DEVELOPMENT APPLICATION ASSESSMENT REPORT

Application Number:	DA2023/0160
----------------------------	-------------

Responsible Officer:	Megan Surtees
Land to be developed (Address):	Lot 24 DP 7953, 36 Rednal Street MONA VALE NSW 2103 Lot 265 DP 752046, 36 Rednal Street MONA VALE NSW 2103
Proposed Development:	Alterations and additions to a dwelling house
Zoning:	C4 Environmental Living
Development Permissible:	Yes
Existing Use Rights:	No
Consent Authority:	Northern Beaches Council
Land and Environment Court Action:	No
Owner:	Michael Thomas Johnson Adrienne Patricia Johnson
Applicant:	Michael Thomas Johnson

Figure 1. 9am Shadow Diagram (orange shading indicates additional shadowing).

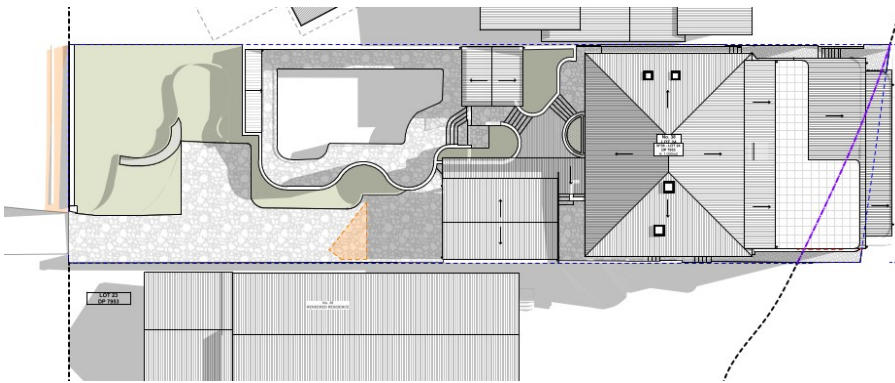
The proposed development has been designed and sited in such a way that allows for solar access during mid-winter to adjoining properties, as indicated in the shadow diagrams above.

Figure 4. Northern elevation envelope breach indicated in pink (yellow indicates existing breach).

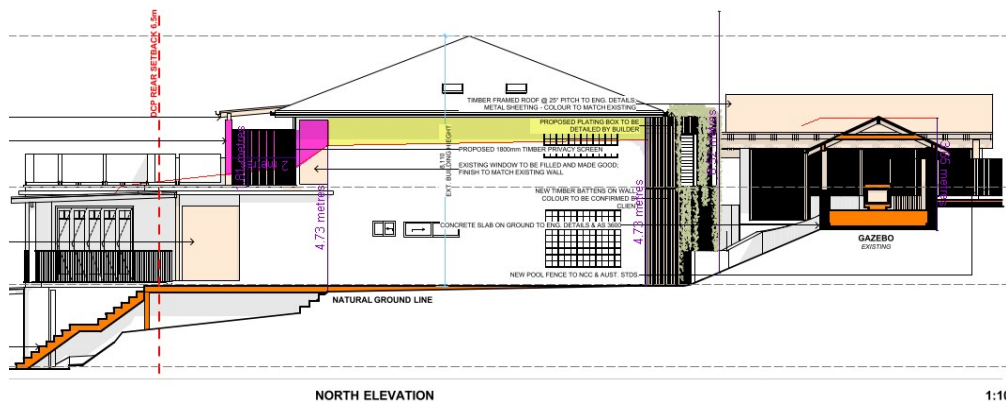
This control requires development to be sited within a building envelope which is measured from the side boundaries at a height of 3.5 metres, then angled inward at 45 degrees. The proposed development extends beyond the prescribed envelope along both the northern and southern elevations, as indicated in the figures below.

Council may consider a variation for the addition of a second storey where the existing dwelling is retained. In this instance, the non-compliance will be considered against the variation of this control.

Figure 6. Landscaped lawn seaward of the MHWM (indicated in green, rear boundary line indicated in red).

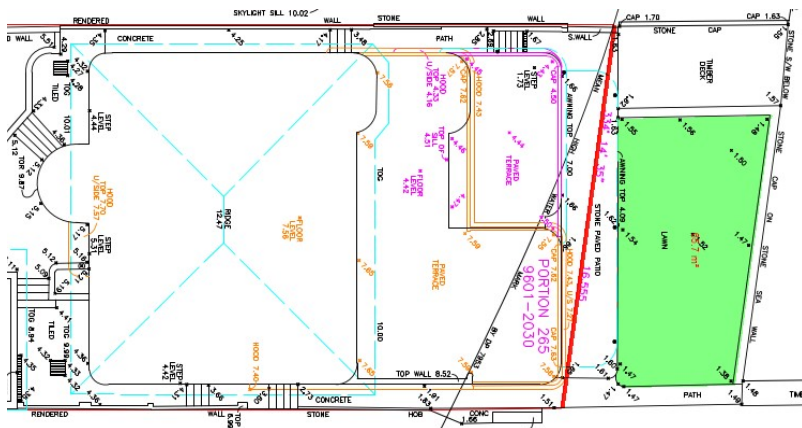
The subject site is located within Landscaped Area 1, which requires 60% (or 602.4m²) of the site to be dedicated to landscaped area. The proposed development will result in a landscaped area of 18.8% (or 188.81m²). There is a lawn area seaward of the Mean High Water Mark (MHWM), which is 65.7m² (see below Figure). However, while this area is used by the occupants of the subject site, this area is not within the property boundaries and cannot be included within the numeric landscaped area calculation.

The existing landscaped area, excluding the lawn seaward of the MHWM, is 17.3% (or 173.77m²).
